Access Compliance Report

Public Rights-of-Way

Intersection ID: 44831	Main Street: ST_JOHNS_CHURCH_RD	Cross Street: DECAPOLIS_DR	Location: NW
ADA ID: 8D7F93CA6D62	Ramp Type: Perp	Initial Pass/Fail: Fail	Overall Compliance: No
Severity Score: 10			
Codes/Mitigation Info/Possible Solution		Field Measurements/Component Compliance

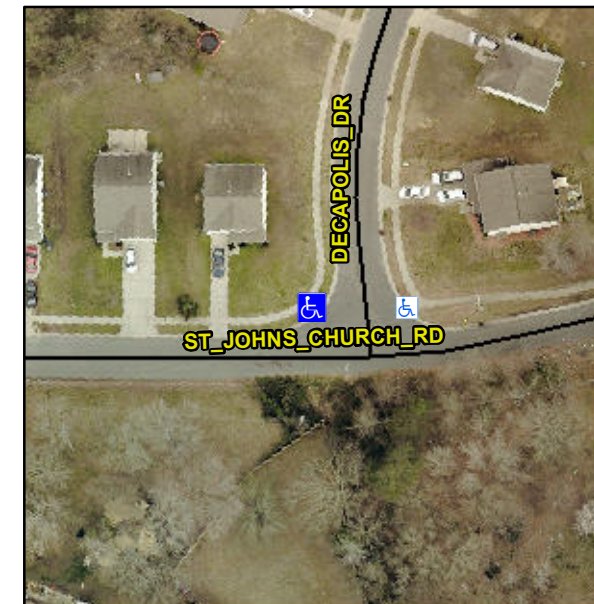
Not Found, R304.5.1, R304.5.3

Compliance	Description	Data	Compliance	Description	Data
N/A	Ramp Length (in)	59.0	Yes	Ramp Slope (%)	6.1
No	Ramp Width (in)	47.0	No	Ramp XSlope (%)	4.2
N/A	Flare Type LT	N/A	N/A	Flare Type RT	N/A
N/A	Flare Slope LT (%)	N/A	N/A	Flare Slope RT (%)	N/A
N/A	Flare Traversable LT?	N/A	N/A	Flare Traversable RT?	N/A
N/A	Landing Length (in)	N/A	N/A	DWS Provided?	N/A
N/A	Landing Width (in)	N/A	N/A	DWS Contrast?	N/A
N/A	Landing Slope (%)	N/A	N/A	DWS Length (in)	N/A
N/A	Landing X Slope (%)	N/A	N/A	DWS Full Width?	N/A
N/A	Landing Curb? (Y/N)	N/A	N/A	DWS Offset (in)	N/A
N/A	Shared Landing?	N/A			
N/A	Gutter Ponding?	N/A	N/A	Gutter Slope (%)	N/A
N/A	Gutter Lip Ht (in)	N/A	N/A	Gutter X Slope (%)	N/A
N/A	Painted X Walk1?	No	N/A	Painted X Walk2?	N/A
	X Walk 1 Direction	To E		X Walk 2 Direction	N/A
N/A	X Walk 1 Width (in)	N/A	N/A	X Walk 2 Width (in)	N/A
	X Walk 1 Slope (%)	4.5		X Walk 2 Slope (%)	N/A
	X Walk 1 X Slope (%)	1.5		X Walk 2 X Slope (%)	N/A

Remove & Replace Entire Ramp.
